ENGINES 900.92, 902.93, 924.93, 926.95 /97, 457.94 /95 /96, 458.99, 541.95, 542.96, 941.99, 942.99 in MODEL 000.001 with BlueTec®

BT	Pressure reservoir for pump module changed		BT14.40-W-0003-01A
1.1.1	Remove protective cap (7) and valve cap (6)	Previous version  The previous version must no longer be installed. The assembly should be performed according to the new version.

W14.40-1527-06

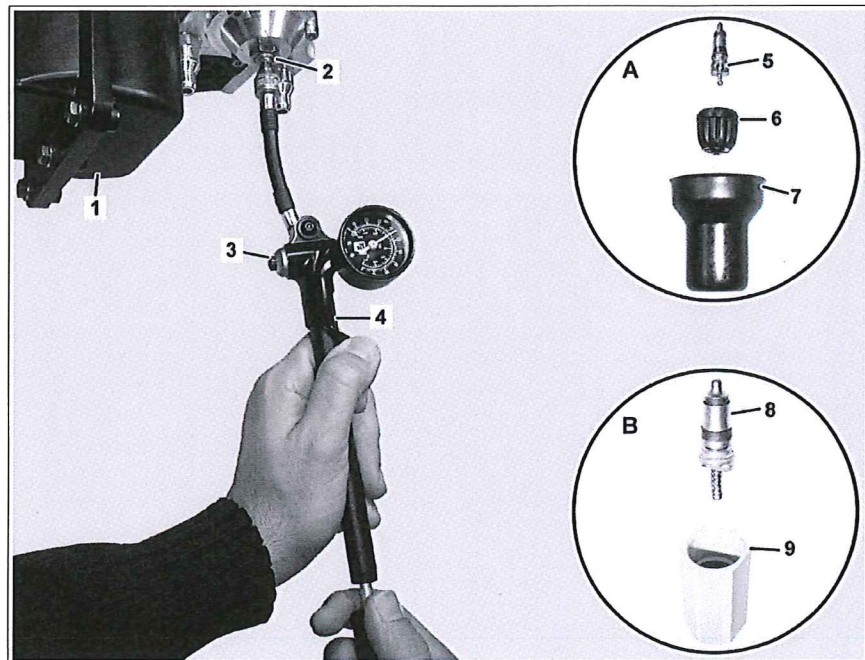
1.1.2	Reduce pressure in pressure reservoir	Previous version  Press in valve element (5).	
1.1.3	Remove valve element (5) and install valve element (8)	Previous version

1.2	Remove valve cap (9)	New version	
	Checking		
2	Screw filling hose for pump (4) onto the filler connection (2)	 Pump	*001589007100
3	Read off pressure on pump pressure gauge (4); adjust the pressure if necessary	 Pumping causes the pressure to be increased; the pressure is reduced through pressing on the pressure release knob (3) a number of times. Set prescribed pressure about 0.2 bar higher since there is slight loss of pressure when disconnecting the  pump (4) from the filler connection (2) of roughly that order of magnitude which is unavoidable on technical grounds.  The pressure reservoir must always be charged if this was removed/installed or replaced, or the whole pump module (1) was replaced. This is because these are not charged on delivery, either for a single delivery or in the pump module (1).	*BE14.40-N-1001-02F
4	Unscrew filling hose of pump (4) from filler connection (2)	 <ul style="list-style-type: none"> If pump module (1) or pressure reservoir were not replaced, continue with operation step 5. If pump module (1) or pressure reservoir were replaced, continue with operation step 7.
